Centennial / S. Fort Apache Residential Development

CITY OF LAS VEGAS		DATE:
INTER-OFFICE MEMORANDUM		June 13, 2018
TO: Land Development Services Department of Building & Safety		FROM: Albert Sung, P.E. Flood Control Project Engineer Department of Public Works
SUBJECT:	Drainage Study for:	COPIES TO:
	Centennial & Fort Apache Residential Development	Taney Engineering
Cross Streets:	SWQ Fort Apache Rd. & Centennial Blvd.	Adaven Homes
File Number:	F:\Depot\DSMemos\DS4994A.doc	Bart Anderson, P.E., DevCo
Parcel Number:	125-30-502-009	CCPW
Zoning Action:	TMP-72410; VAC-72409; WVR-72408 & VAR-72407	
FEMA Flood Zone	YES	NO X
Proposed Storm Drain	YES	NO X

Taney Engineering is pleased to provide Addendum #1 to the Technical Drainage Study for **Fort Apache and Centennial**. This addendum includes a response to each comment from City of Las Vegas review memorandum dated on June 13, 2018. The comments have been reproduced and addressed as follows:

FILE NAME: S:\ACTIVE\ADAVEN HOMES\ADV-17-086 - FORT APACHE & CENTENNIAL PKWY\PRODUCTION\DWG\SSHEET\DWG\ADV17086_SHT_G1.DWG

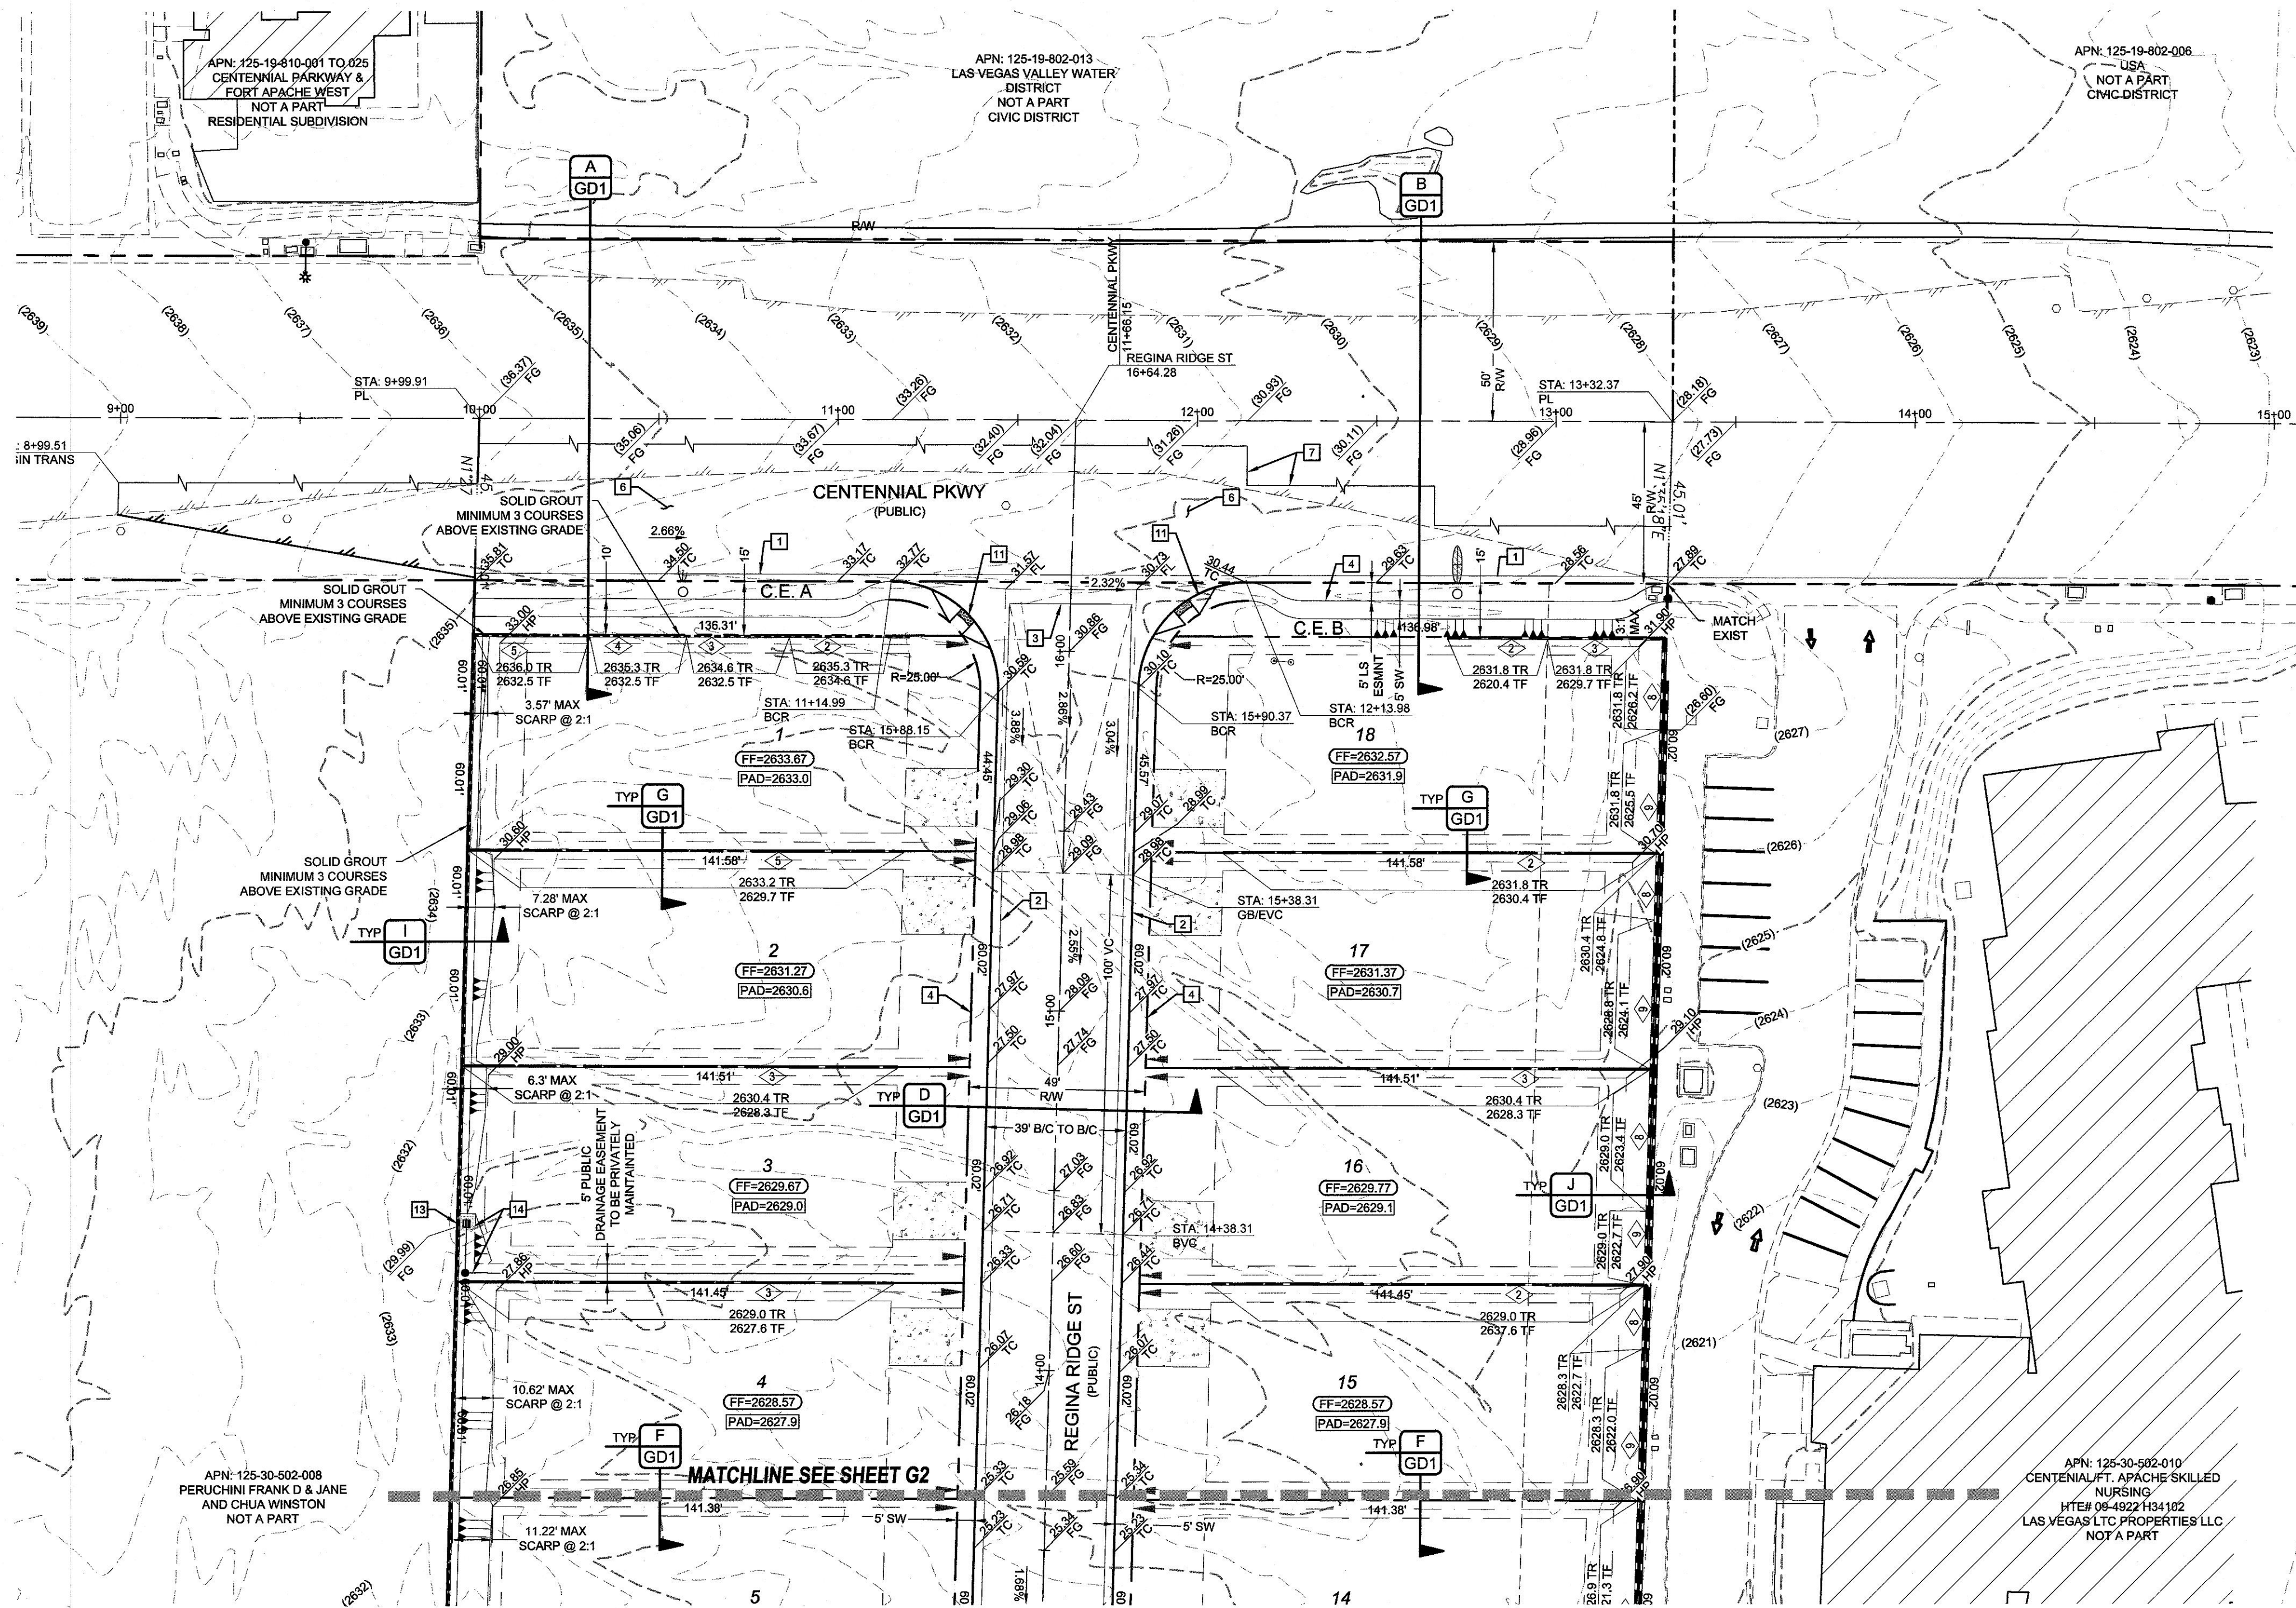
Comment 7: Construction Notes 13 and 14 are shown on the plans, but are not described in the construction notes on sheets G1 and G2. Address in the next submittal.

Construction notes have been revised with the plans to reflect this change as requested.

FILE NAME: S:\CTV\ADAVEN HOMES\ADV-17-086 - FORT APACHE & CENTENNIAL\ENGINEERING\PRODUCTION\DWG\ADV-17-086_SHT_G.DWG

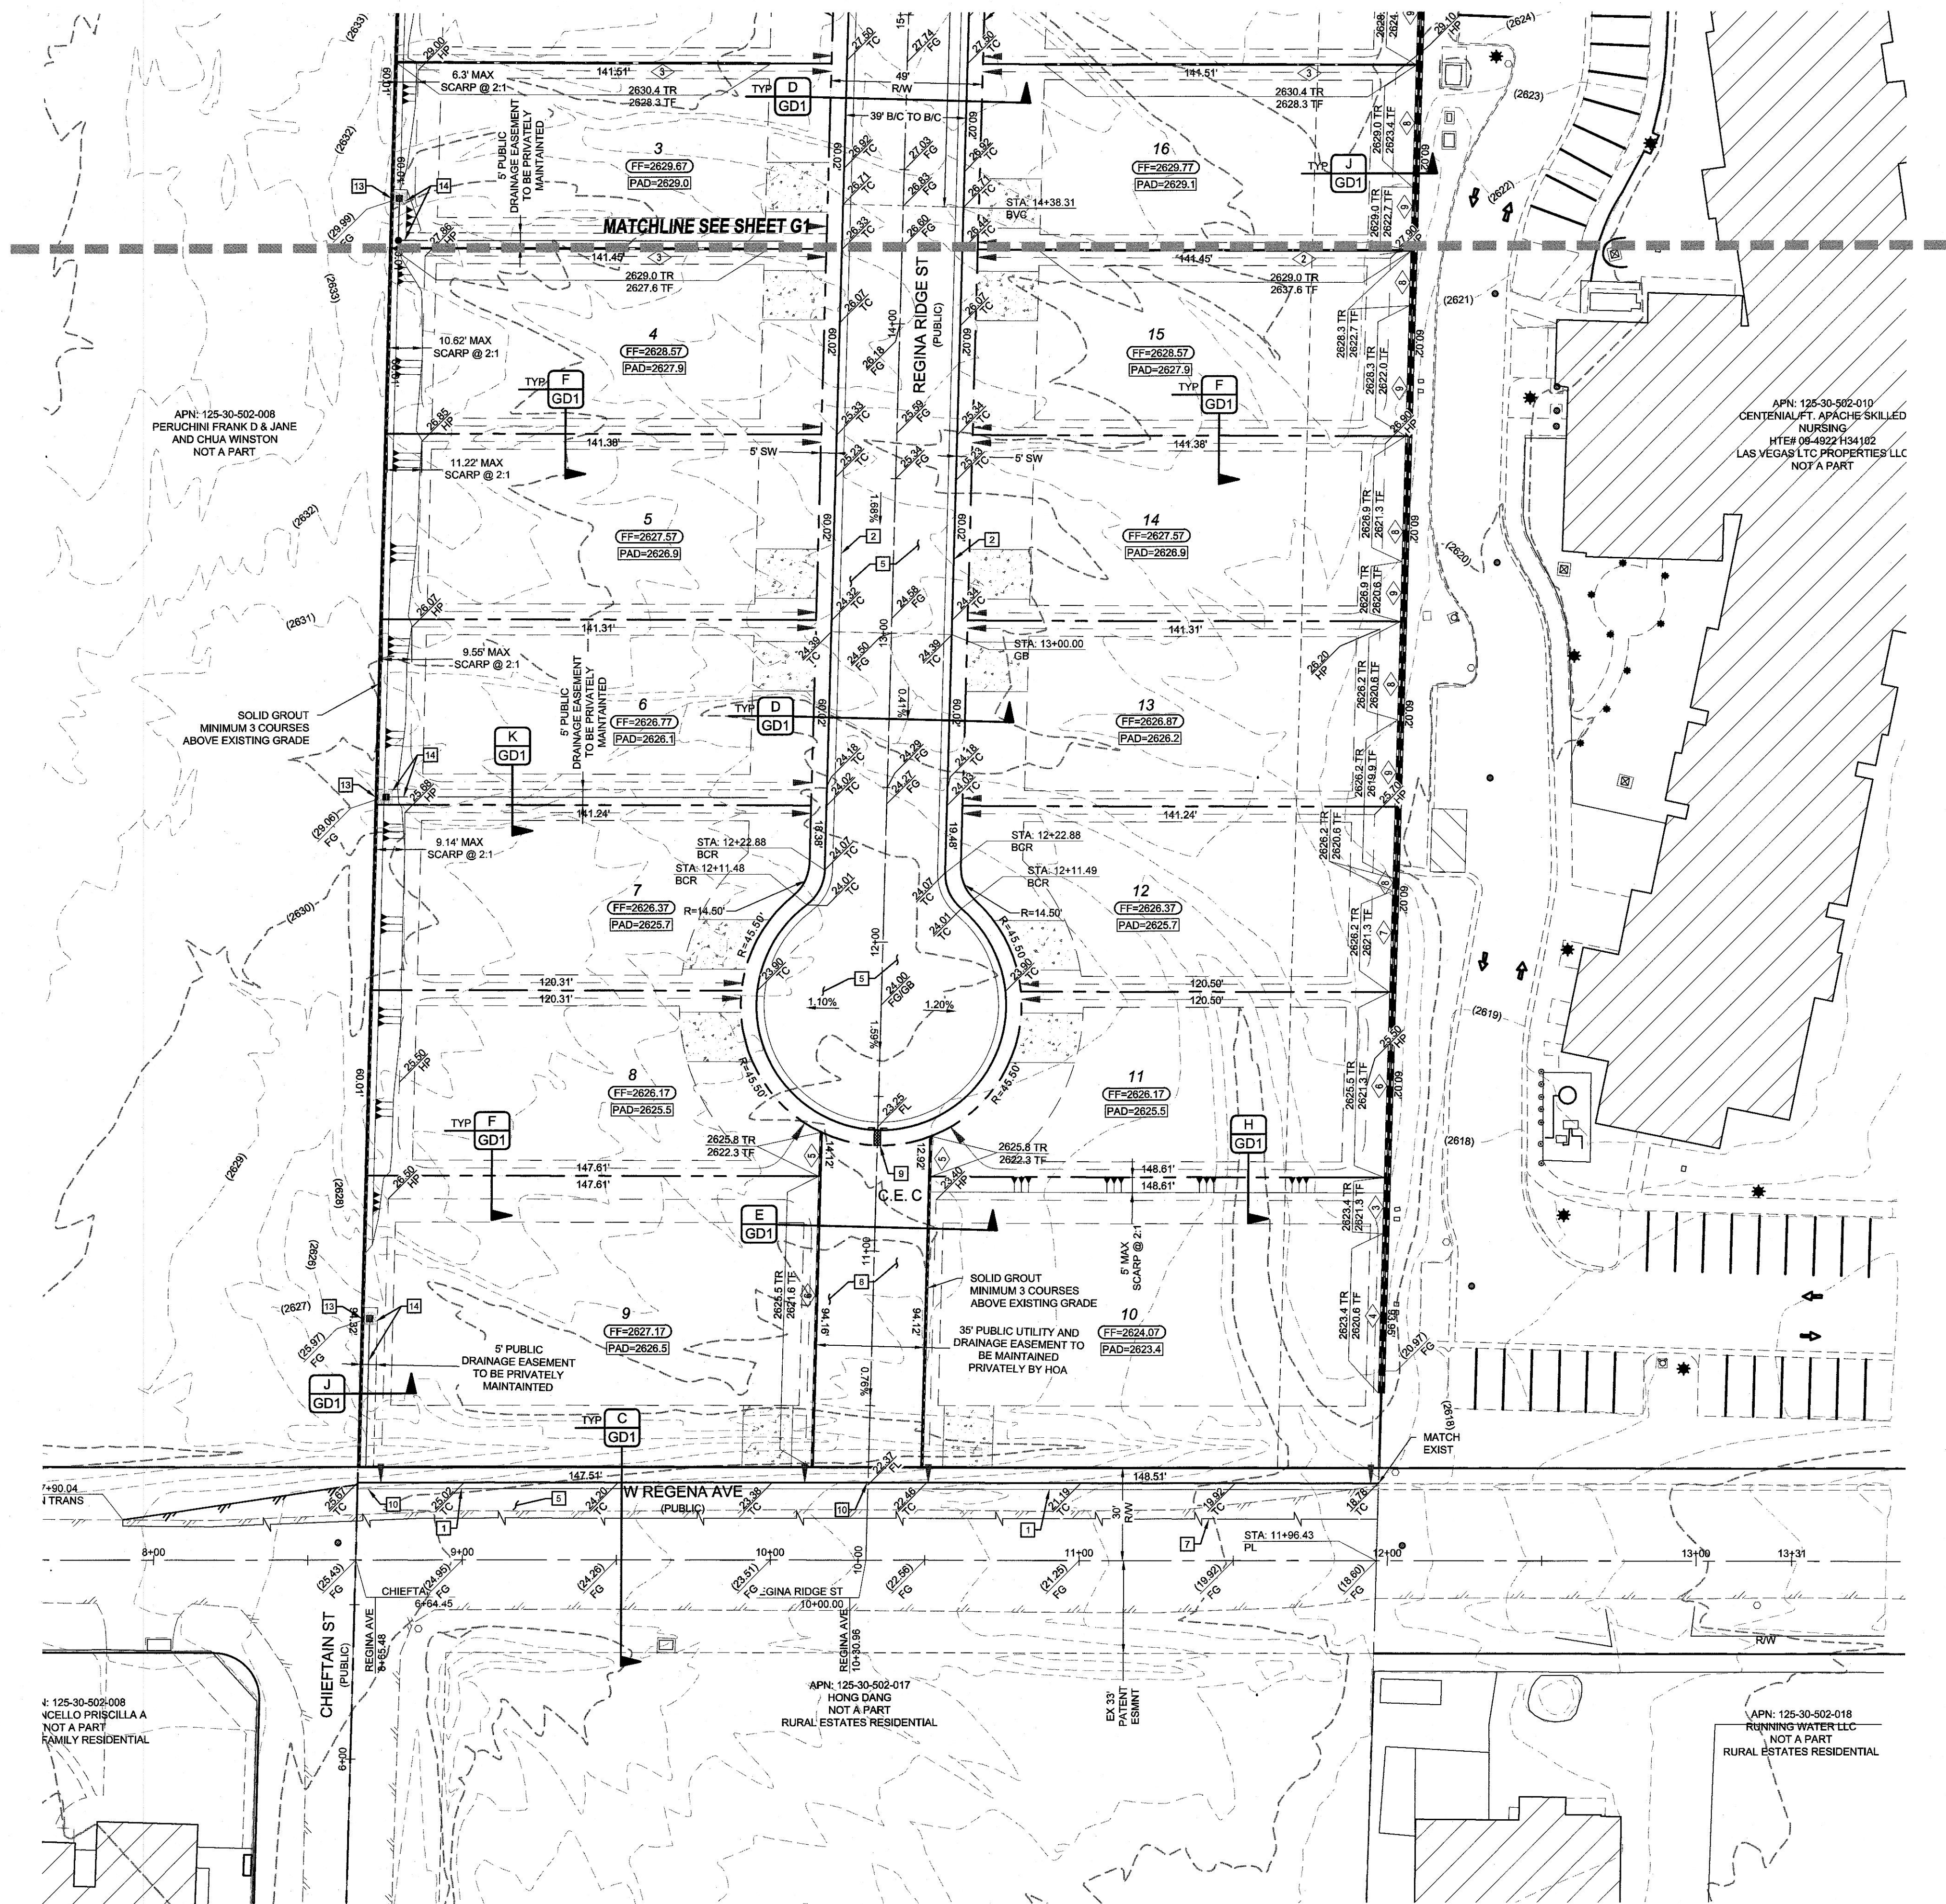
Comment 8: Cross Sections F, G, H, I, J and K are not provided on Sheet GD1, however these cross sections are shown on the plans. Provide as such in the next submittal.

Comment 9: Cross Section A: Provide 3-course of solid grouted 8"-CMU above the adjacent grade in the landscape area.

Comment 10: Revise Cross Section E to show a concrete lined public drainage easement to be privately maintained.

Cross sections have been updated on the grading plans to show the correct cross sections that are shown on GD1 as requested.

Cross section A has been revised to show a 3 course solid grouted 8" CMU wall as requested.

Cross section E has been updated to show a concrete lined public drainage easement to be privately maintained as requested.
